Johnson & Sedlack

June 15, 2015

Re: Valiano Specific Plan, SCH NO. 2013061042—Public Comments on Draft Environmental Impact Report

The following comments are submitted on behalf of the Elfin Forest Harmony Grove Town Council regarding the Draft Environmental Impact Report (DEIR) for the Valiano Specific Plan Project.

-  RPO WETLANDS— MUST BE DEDICATED BIOLOGICAL OPEN SPACE
-  RPO WETLANDS BUFFER— 50' AROUND RPO WETLANDS, PLUS UP TO 200' OF COAST LIVE OAK WOODLAND WHERE ADJACENT TO RPO WETLANDS— MUST BE DEDICATED BIOLOGICAL OPEN SPACE
-  BUILDING ENVELOPE
-  FUEL MODIFICATION ZONE— 150' FROM BUILDING ENVELOPE

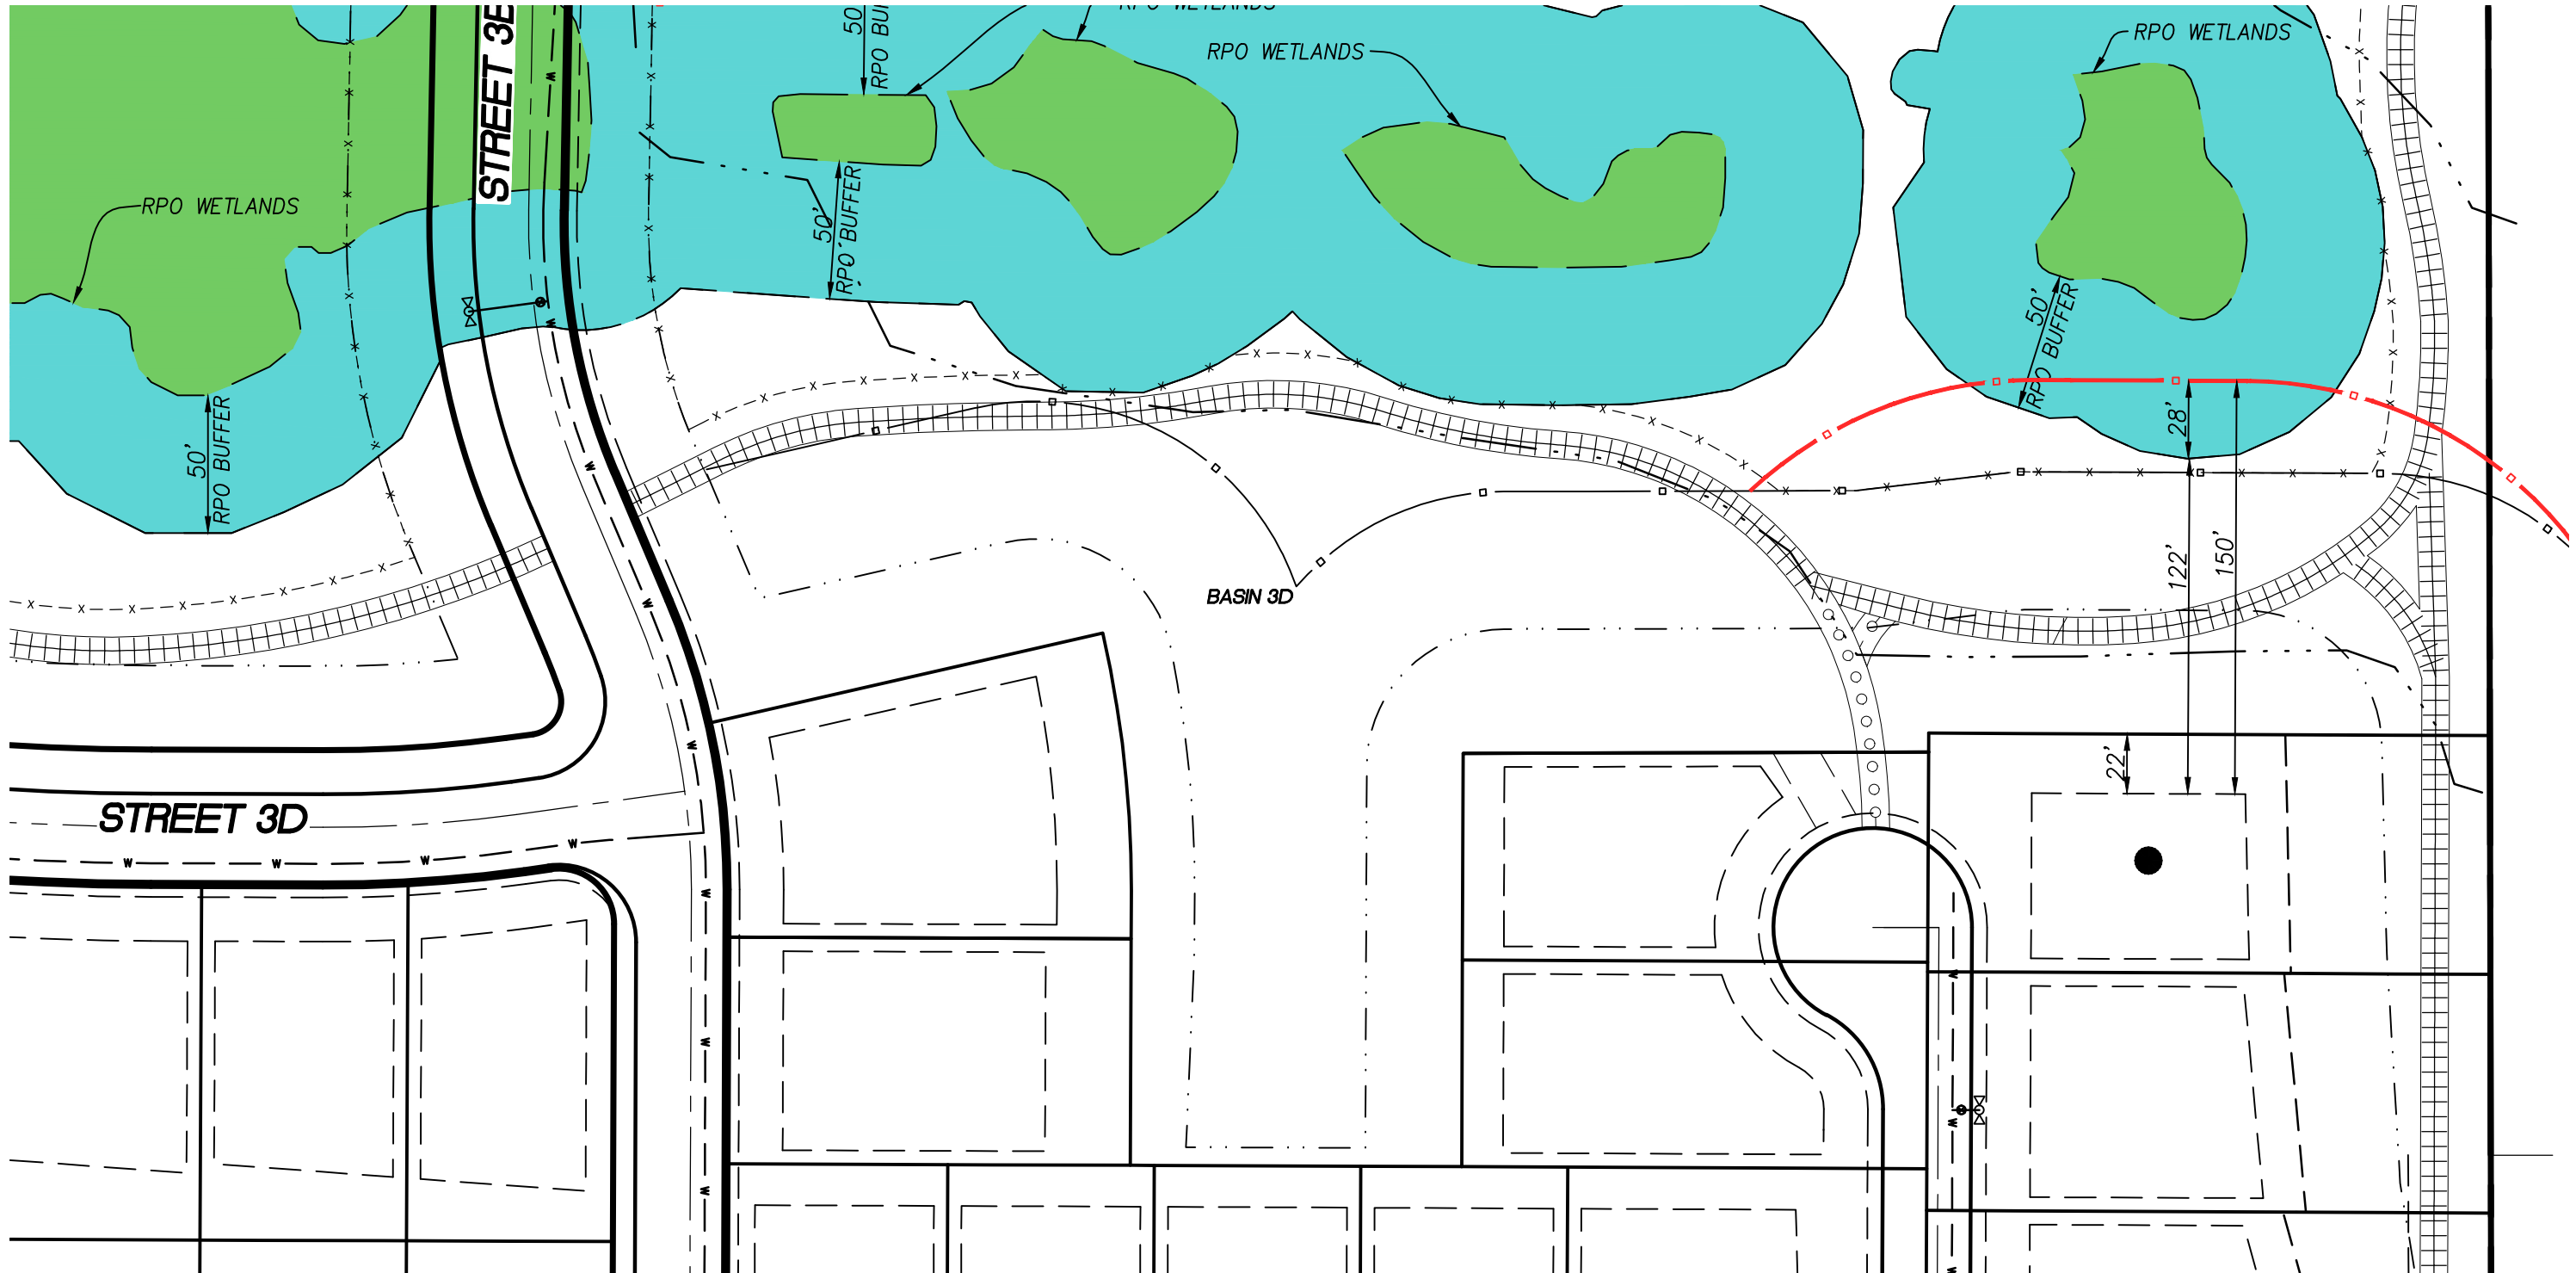
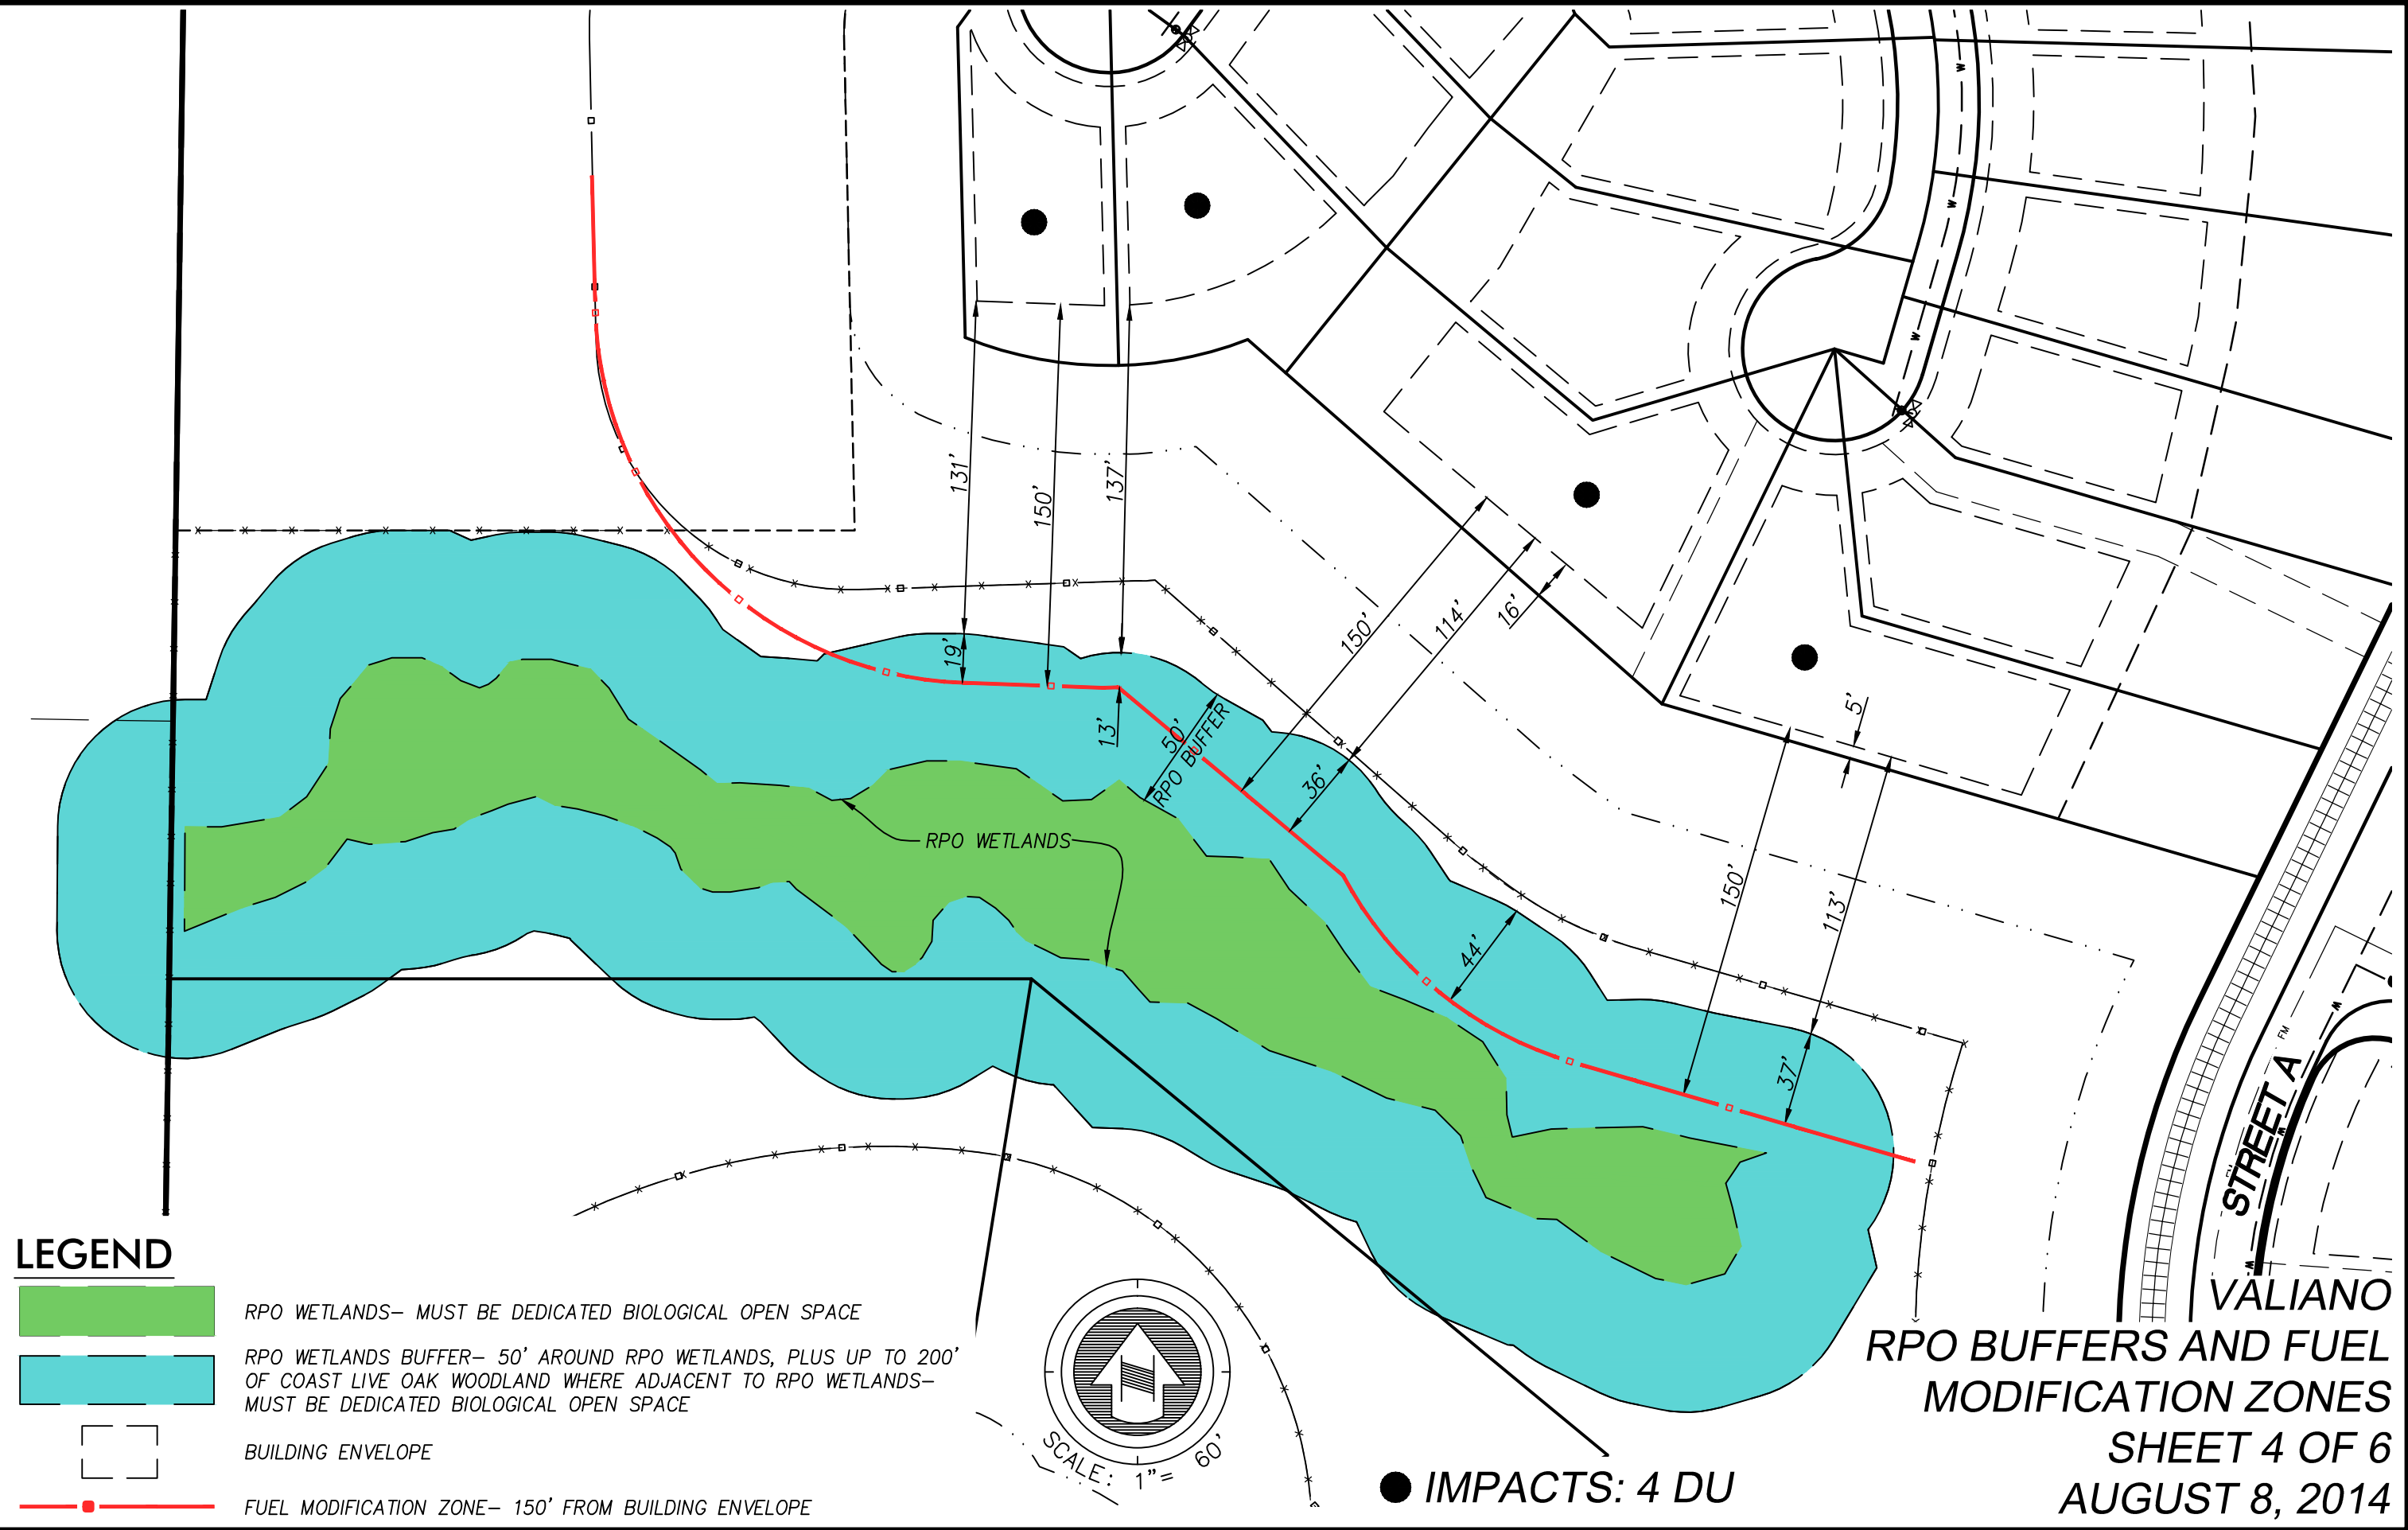
- Do FMZs overlap with areas required for biological mitigation? *See*, attached **Exhibit B** (August 14, 2014 site drawings)
- Section 4.5.3 of Appendix L states regarding Zone 3 (the off-site perimeter parcels which provide the required 150-foot fuel treatment zone for select Project parcels) that adjacent properties will provide the required modification of hazardous fuels 150 feet from off-site structures. There is no assurance that easements can be obtained.
